**From:** Eric Jantz <ejantz@nmelc.org>  
**Sent:** Thursday, May 27, 2021 7:27 PM  
**To:** UNC-ChurchRockEIS Resource  
**Cc:** Waldron, Ashley  
**Subject:** [External\_Sender] Docket ID: NRC-2019-0026, NUREG 2243; Red Water Pond Rd. Community Association comments on DEIS A  
**Attachments:** RWPRCA DEIS Comments FINAL.pdf; Peterson Bell FINAL declaration\_052721.pdf

Re: Docket ID NRC-2019-0026, Red Water Pond Road Community Association  
Comments on Waste Consolidation Draft Environmental Impact Statement [License No.  
NUREG-2243]

Please accept the following comments on behalf of the members of the Red Water Pond Road Community Association ("Community") on the U.S. Nuclear Regulatory Commission's ("NRC") Draft Environmental Impact Statement for the Disposal of Mine Waste at the United Nuclear Corporation ("UNC") Mill Site in McKinley County, New Mexico NUREG-2243 ("DEIS").

Figure 3. Self-reported environmental exposures among Churchrock participants compared with All Chapters

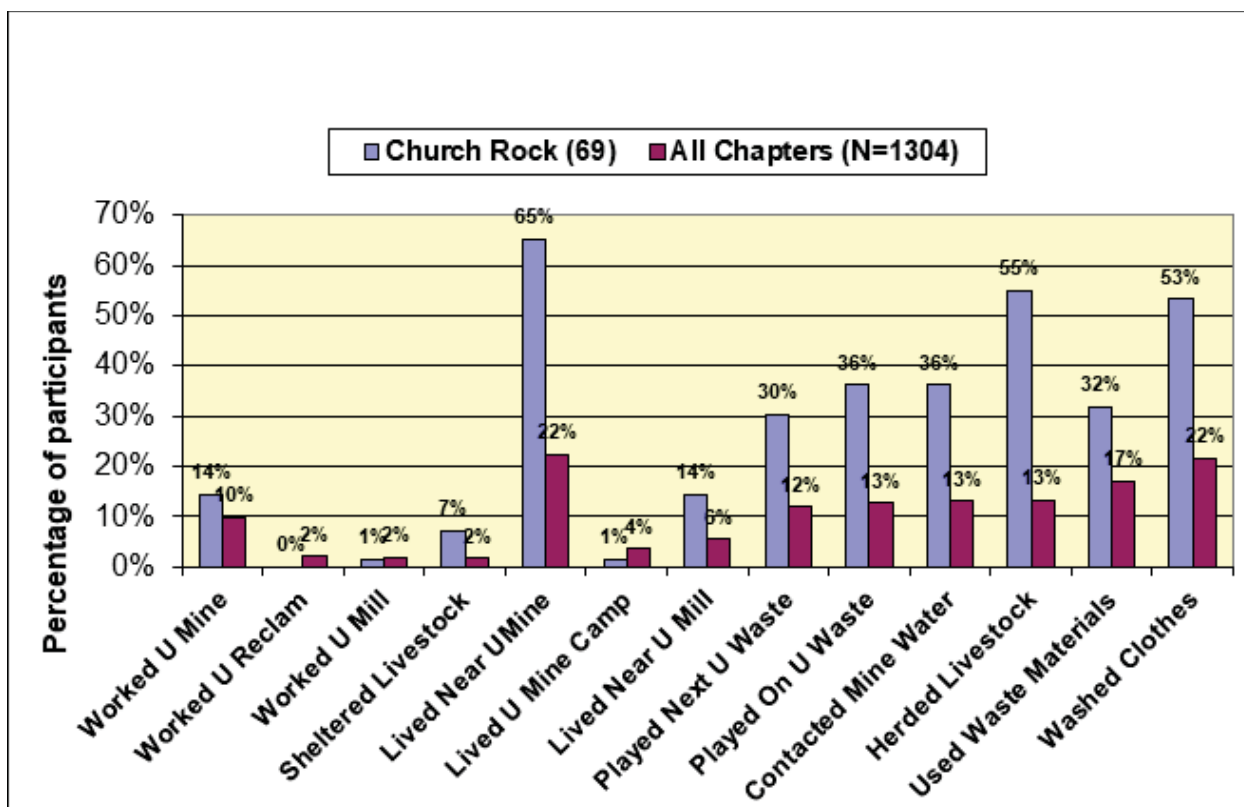
Between 2004 and 2011, the DiNEH Project conducted a water, land use and health survey among 1,304 residents of the Eastern Agency using Navajo-fluent and trained interviewers. In 2010-2011, the study hosted 14 community “collection events” at chapter houses, community centers and clinics at which 267 participants volunteered to provide blood and urine samples for analyses of metals and biomarkers of organ damage. Investigators ascertained exposure by calculating the distance from participants’ homes to 100 uranium waste sites (98 mines and 2 mill tailings facilities) and analyzing participants’ survey responses to 13 questions addressing how they may have been exposed in the past. Exposures range from working in mines, mills or on reclamation projects and living in mining camps to playing on waste piles, herding livestock on or near mine sites, and washing clothing of uranium workers. Nearly 200 participants were residents of Church Rock (69), Coyote Canyon (65) and Pinedale chapters (64) – three of the four chapters that span the Church Rock Mining District. Figure 3 shows that participants living in Church Rock Chapter generally reported more environmental exposures than all DiNEH participants, due largely to the fact that 20 abandoned uranium waste sites (19 mines and 1 mill) are located in the Church Rock area.

**Figure 4. Comparison of Prevalence rates for selected chronic diseases among DiNEH Project Participants, 2012 (from, Shuey, et al., 2019)**

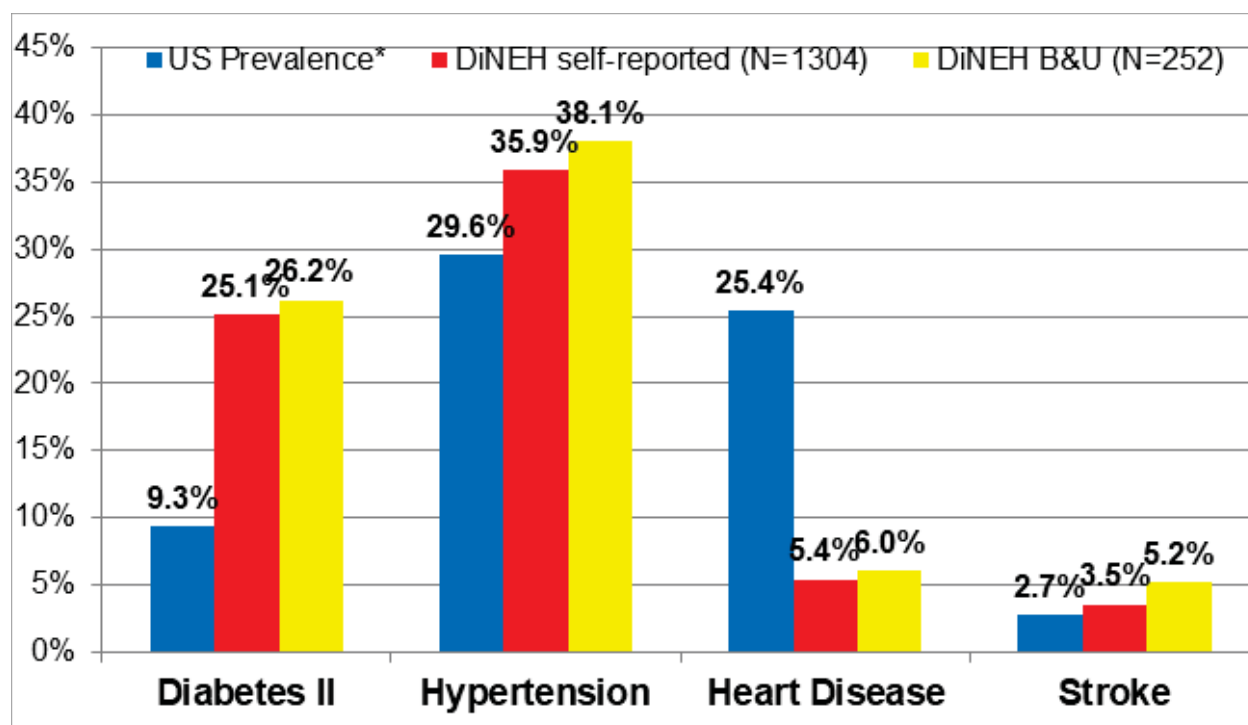
Self-reported and clinically established diseases among DiNEH participants compared with U.S. prevalence rates for key chronic diseases are shown in Figure 4. Prevalence of high blood pressure, diabetes and stroke was greater than U.S. rates; heart disease was one-fourth of the U.S. prevalence rate. UNM researchers applied advanced analytical methods to the survey, geospatial and biological data. Among the salient findings were:
